Access Compliance Report

Public Rights-of-Way

Intersection ID: 13809	Main Street: CHESTERFIELD_AV	Cross Street: ST_JULIEN_ST	Location: W
ADA ID: 9362C8B1D37E	Ramp Type: BlendTrans1	Initial Pass/Fail: Pass	Overall Compliance: No
		Severity Score: 2.5

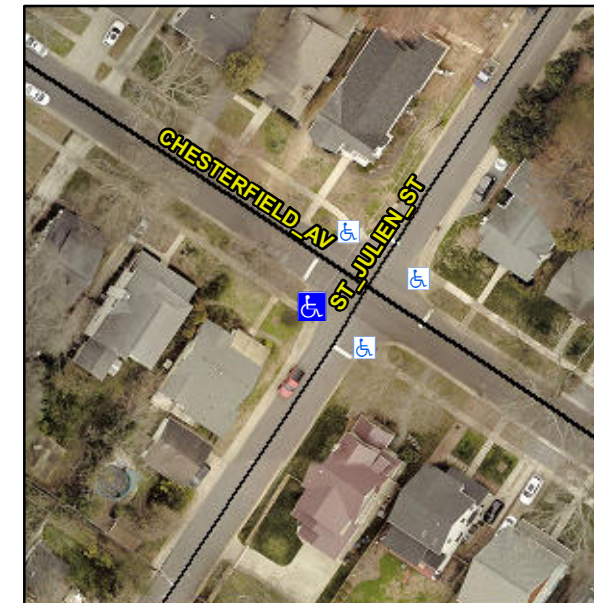
Not Found, R304.2.1, R305.1.4, R305.2, R302.7

Compliance	Description	Data	Compliance	Description	Data
N/A	Ramp Length (in)	61.0	Yes	BlendTrans Slope (%)	2.3
Yes	Ramp Width (in)	65.0	Yes	BlendTrans XSlope (%)	1.4
N/A	Flare Type LT	Sloped	N/A	Flare Type RT	Sloped
N/A	Flare Slope LT (%)	3.5	N/A	Flare Slope RT (%)	2.1
N/A	Flare Traversable LT?	No	N/A	Flare Traversable RT?	No
Yes	Landing Length (in)	88.0	Yes	DWS Provided?	Yes
No	Landing Width (in)	42.0	Yes	DWS Contrast?	Yes
Yes	Landing Slope (%)	0.0	Yes	DWS Length (in)	24.0
Yes	Landing X Slope (%)	0.2	No	DWS Full Width?	No
N/A	Landing Curb? (Y/N)	No	No	DWS Offset (in)	5.0
N/A	Shared Landing?	No			
No	Gutter Ponding?	Yes	Yes	Gutter Slope (%)	1.7
Yes	Gutter Lip Ht (in)	0.0	Yes	Gutter X Slope (%)	0.5
N/A	Painted X Walk1?	No	N/A	Painted X Walk2?	No
	X Walk 1 Direction	To SE		X Walk 2 Direction	To NE
	X Walk 1 Width (in)	N/A		X Walk 2 Width (in)	N/A
	X Walk 1 Slope (%)	2.9		X Walk 2 Slope (%)	6.0
	X Walk 1 X Slope (%)	2.5		X Walk 2 X Slope (%)	1.9

N/A	Ramp inside XWalk1?	N/A	N/A	Ramp inside XWalk2?	N/A
	Road Slope (%)	1.9		Clear Space?	Yes
	Road X Slope (%)	3.8	N/A	Clear Space to XWalk (in)	N/A
Yes	Any Obstructions?	No	Yes	Storm Grate/Utility Hazard?	No
	Obstruction Type			Storm Grate/Utility Type	
		N/A			N/A
			Yes	Surface Condition? (G/P)	Good
			No	Curb Slope (%)	8.5

Remove & Replace Curb Ramp With Two New Directional Ramps or Equivalent.
